Version 2 with additional noise report

Easton Estate – A47 Easton to North Tuddenham Road Improvement Scheme

Subject: The A47 North Tuddenham to Easton Development – Deadline Submission Noise

Estate plan highlighting various points

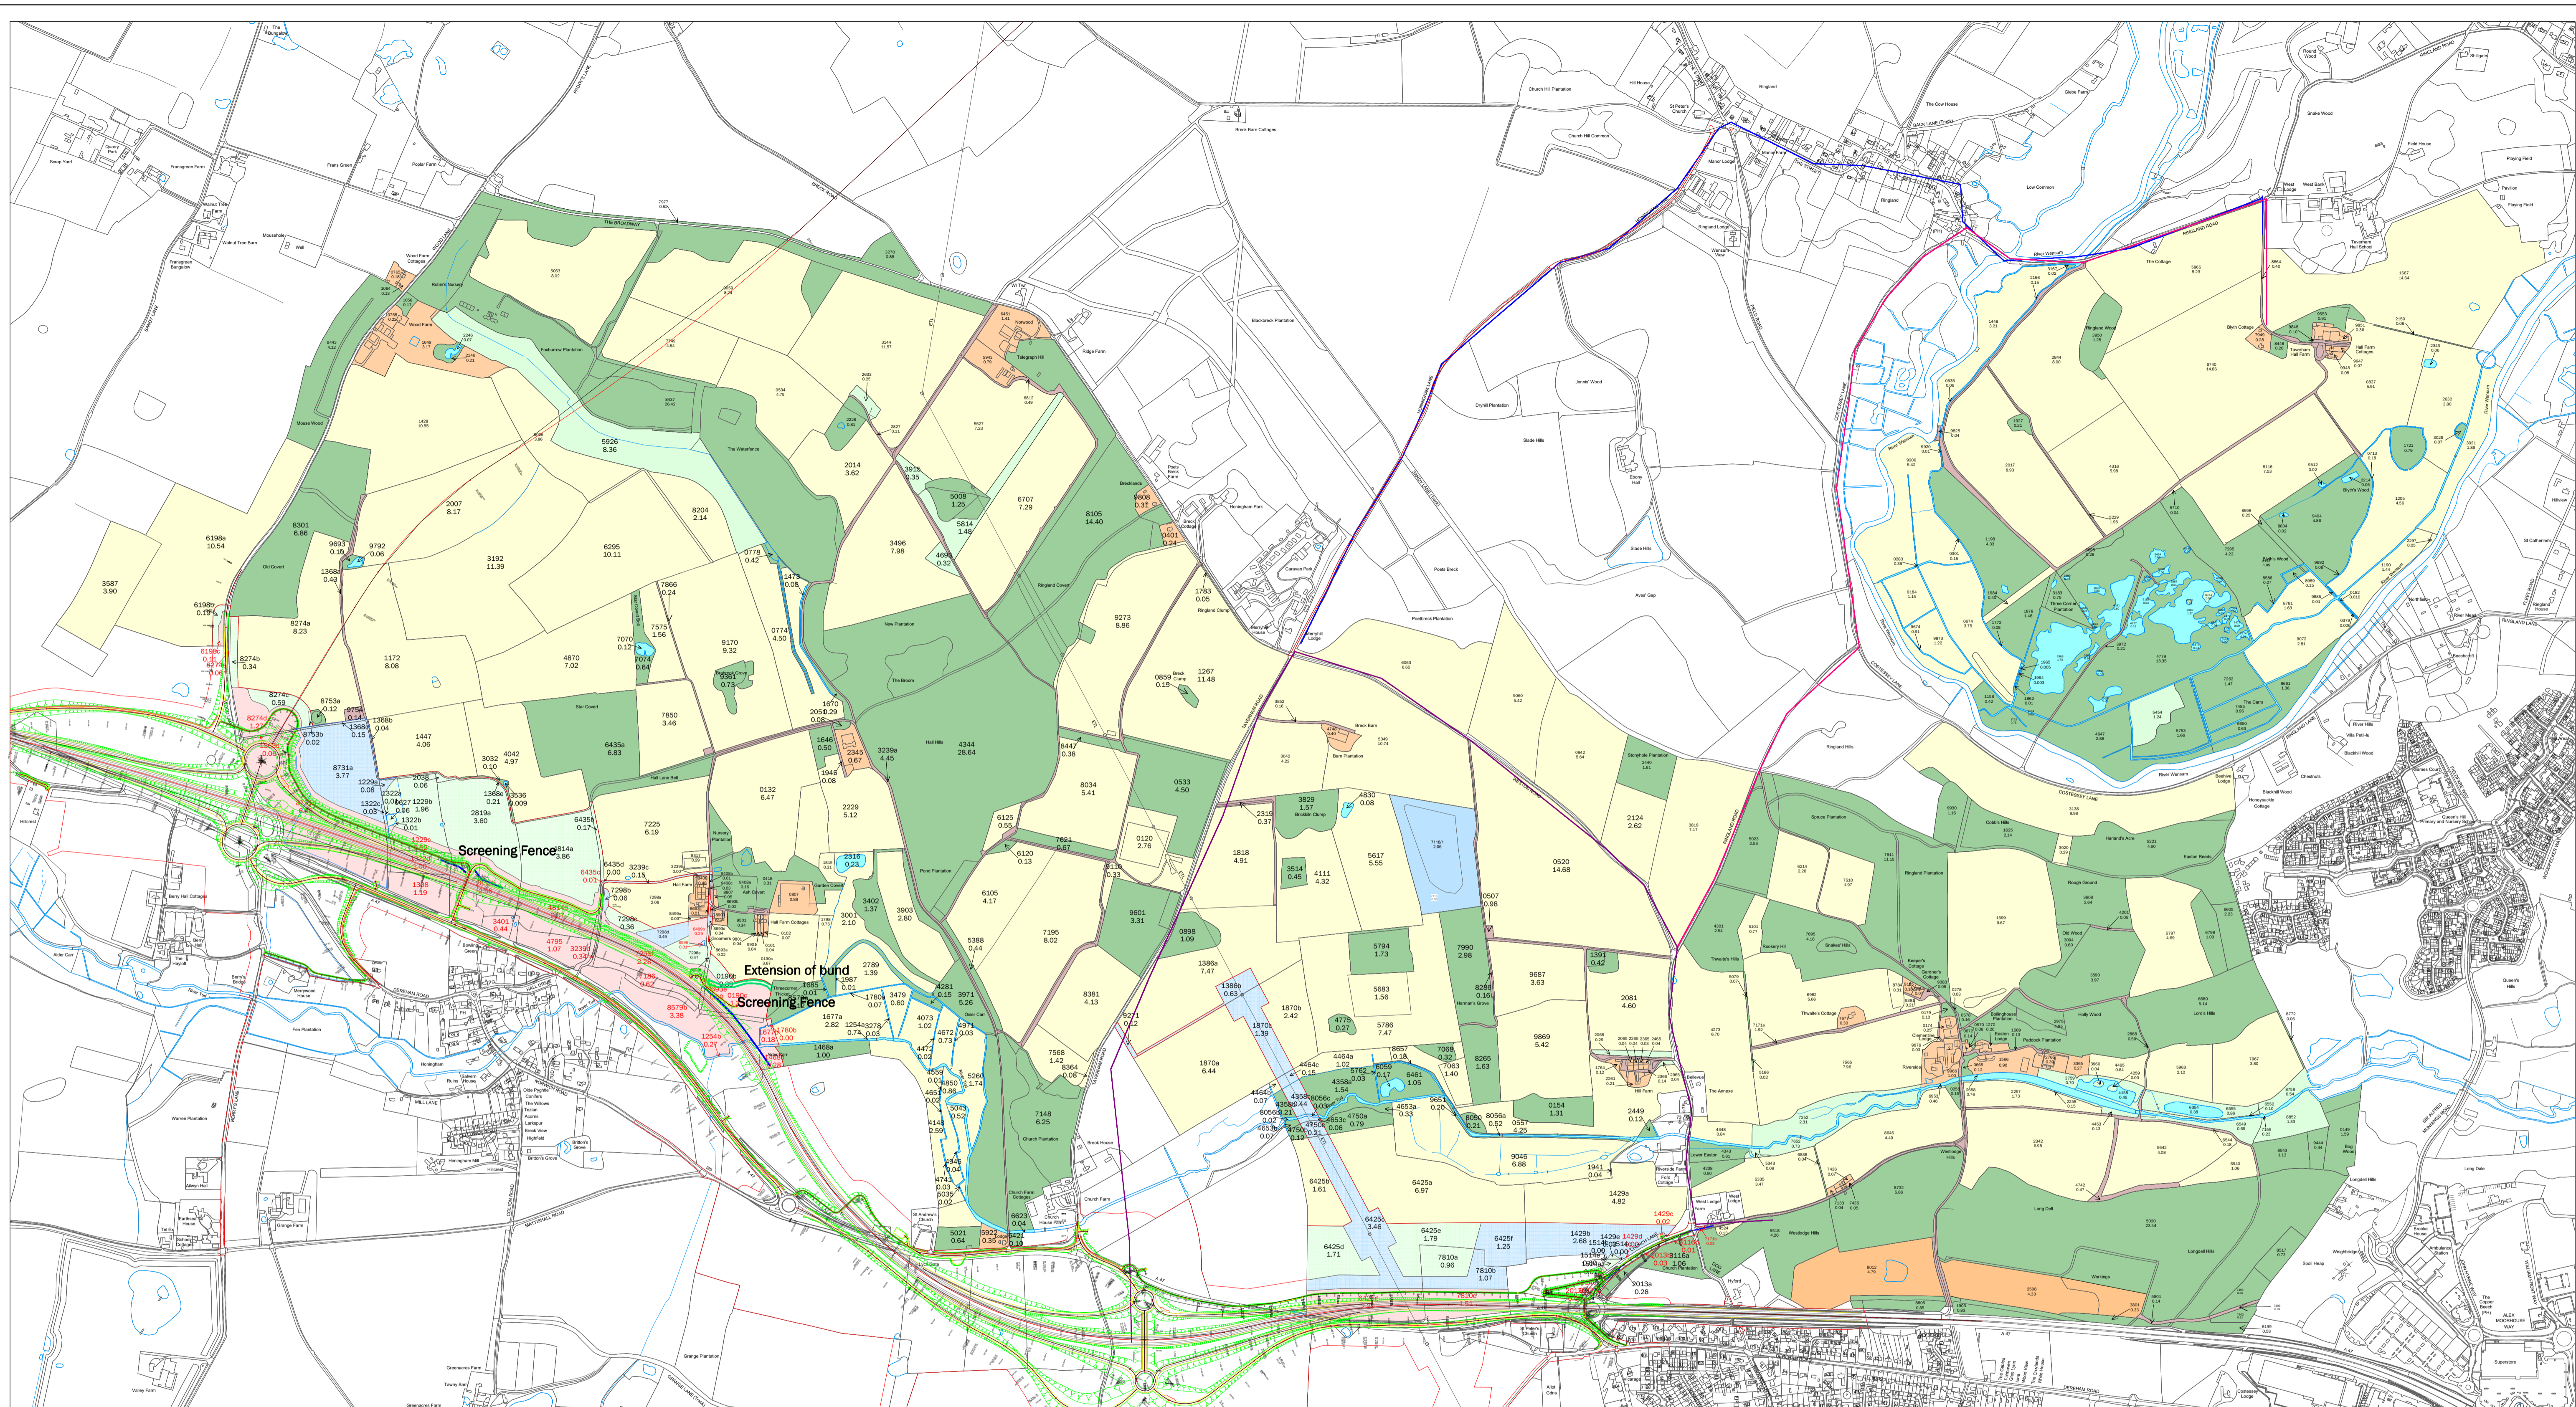
On the plan attached in the appendices, the current route is shown with a purple line progressing northwards to Ringland village along the blue route. The alternative turns east along the purple line and then north on the pink line.

The turn east into Weston Road leads to a very narrow lane, with a particularly difficult junction to turn north into Ringland Road and pass over Ringland Hills which is too narrow for large agricultural vehicles.

Access to the premises at Easton Lodge itself is along Church Lane, immediately accessible from the Easton roundabout which is to be closed. This is shown with a short blue line which takes less than 1 minute to travel safely along.

The alternative is a full 3.25 kms further and far narrower and more tortuous, shown by the long purple route north along Taverham Road, east into Weston Road and then south. This is much longer and much less safe for any vehicle type.

Please could the Inspector ensure that at least the agricultural traffic which can't contend with the alternative road network remains able to pass any temporary or permanent road closure.

Plan extract showing screen fencing

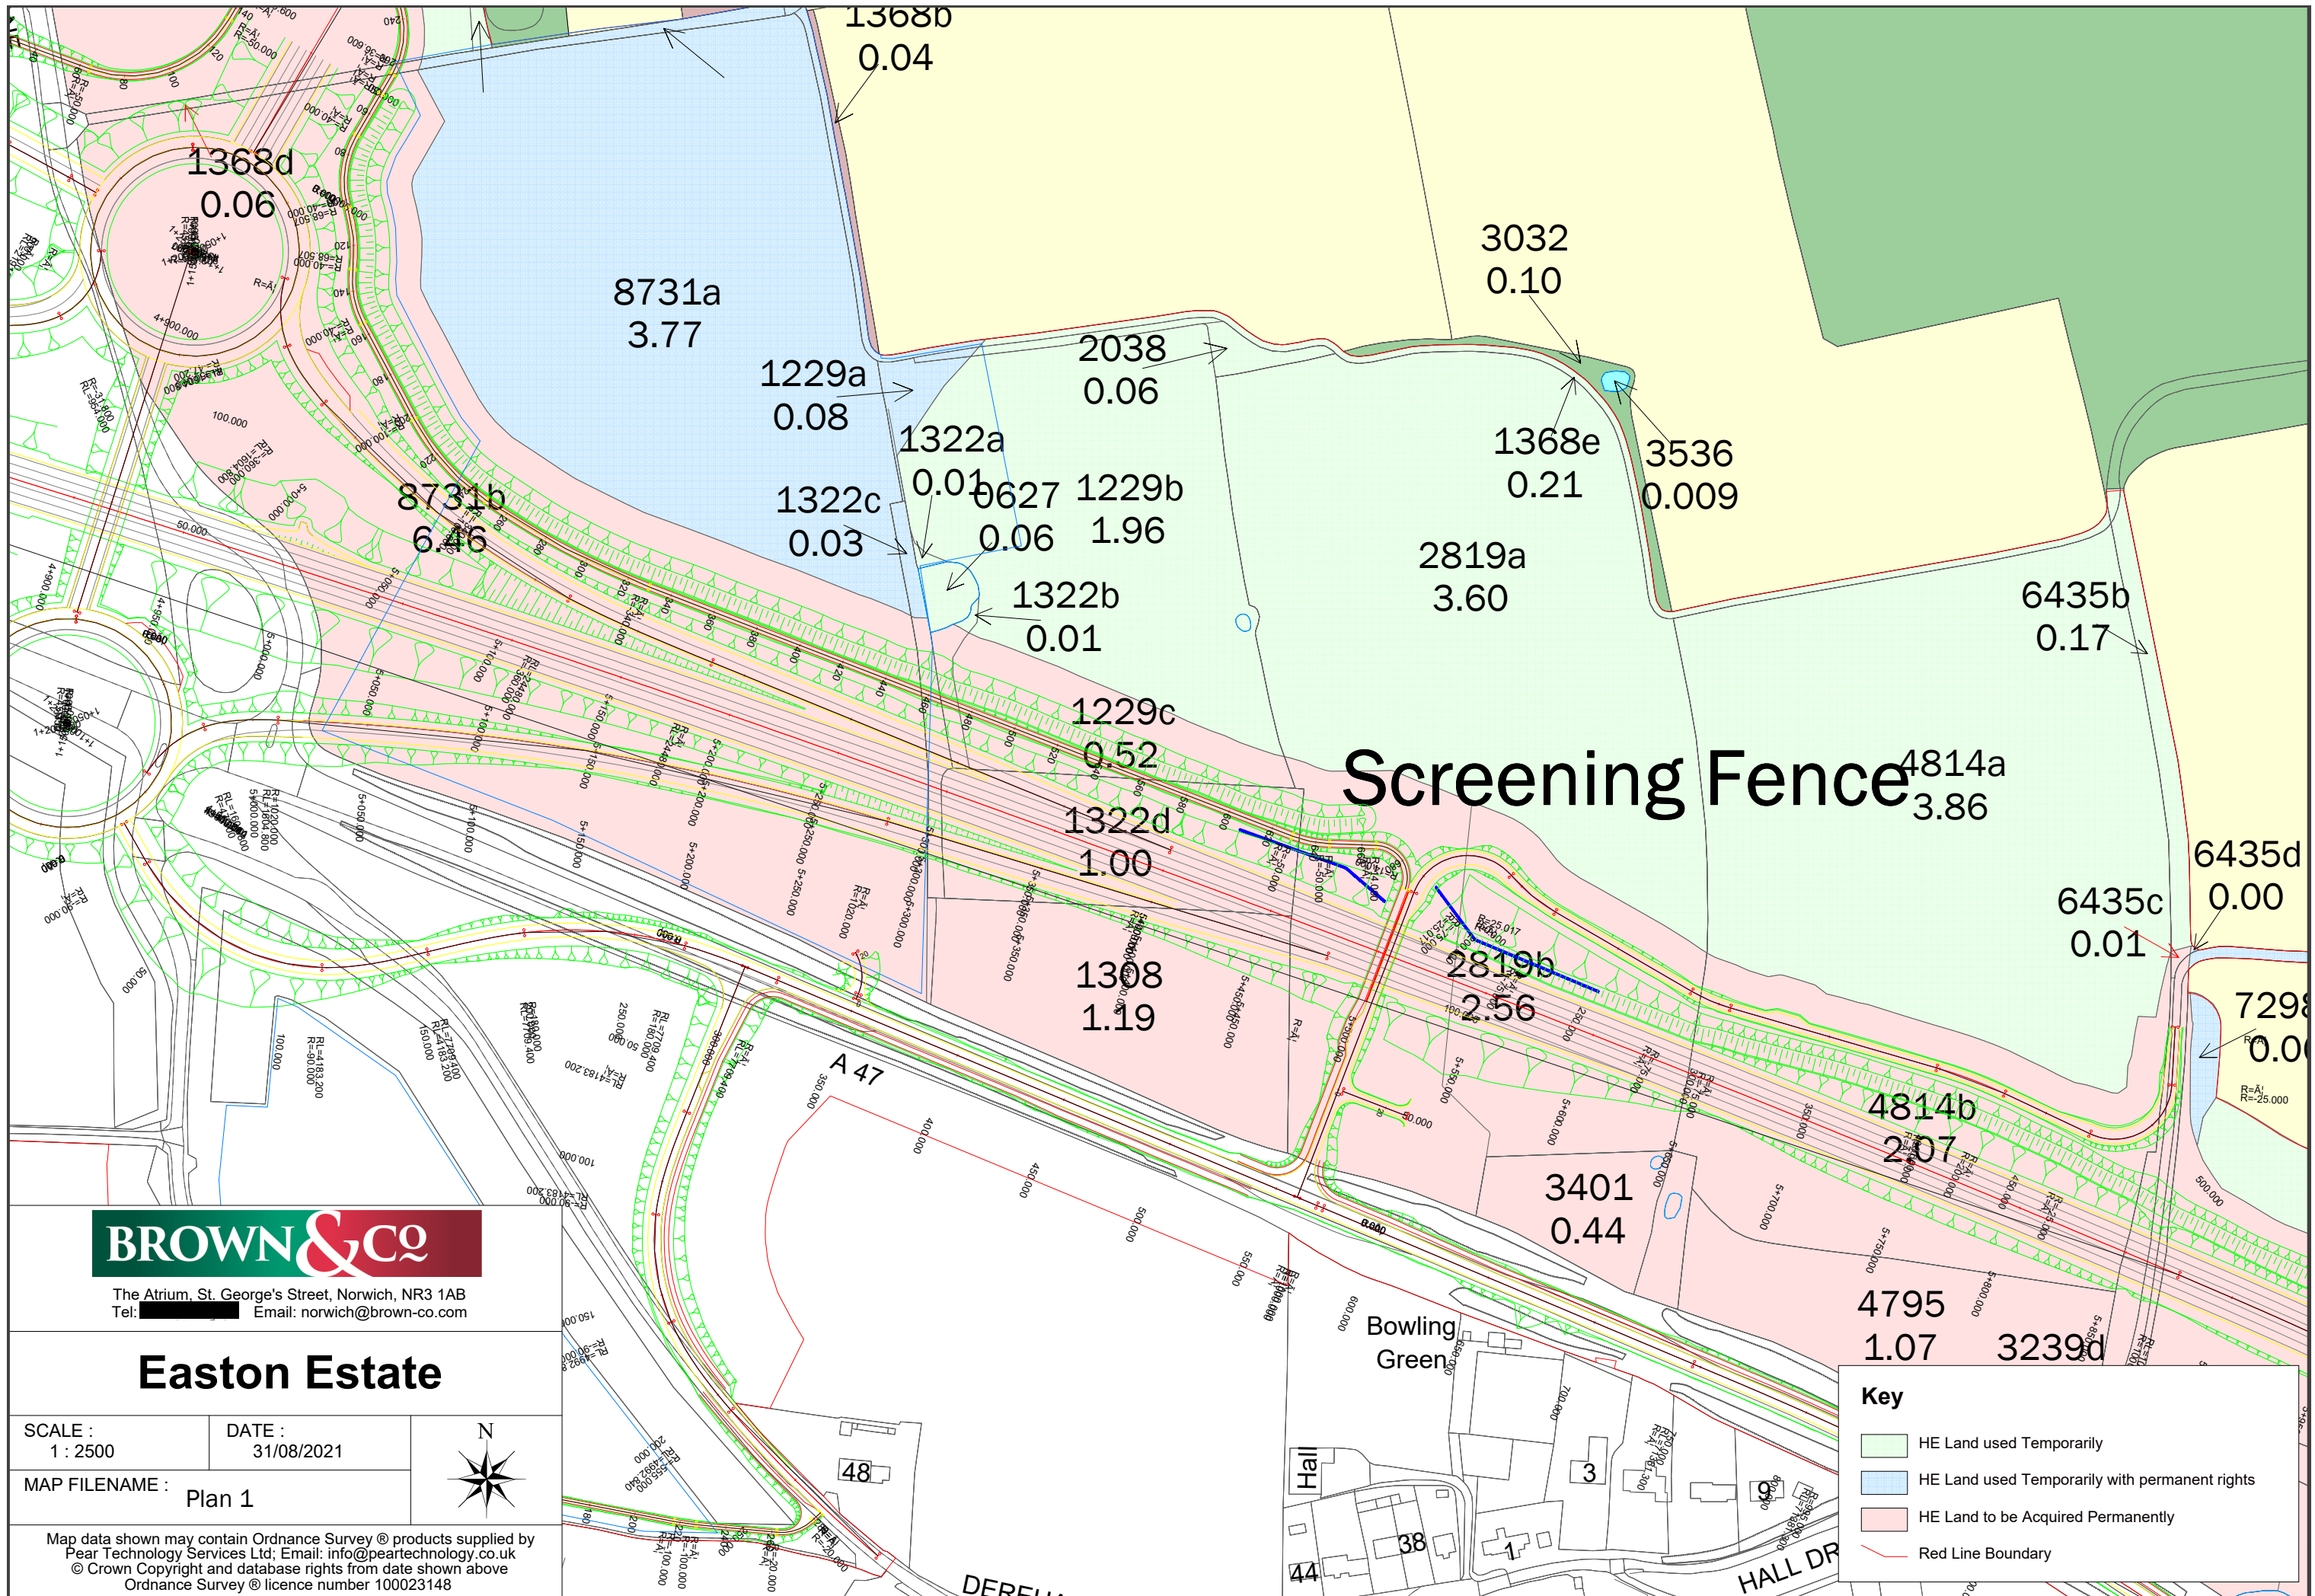
There are two areas we are aware of where screening fencing could add significantly to mitigation measures, but until now the Applicant has declined to discuss them. These are shown approximately in the Appendices.

Hall Farm underpass is situated across a low area in the landscape, so the carriageway will be elevated leaving the estate and the carriageway highly visible. We understand the Applicant doesn't intend to overlap embankments around the access to screen this elevated section, possibly for wildlife reasons.

We have been advised it is not possible to construct a fence on the edge of the carriageway due to wind loading, but a higher-than-normal solid edged safety barrier or a screen fence situated on the adjacent embankment or the edge of the carriageway and carefully designed is likely to mitigate impact from what is a relatively short section of road.

- vi. Increasing the Hall Farm underpass to minimum 5m height, with steel fenced separation for the public right of way for safety of users.
- vii. Suggested 3m fencing along two sections of road, whether at highway edge, highway boundary or on retained estate land as best suits the situation.
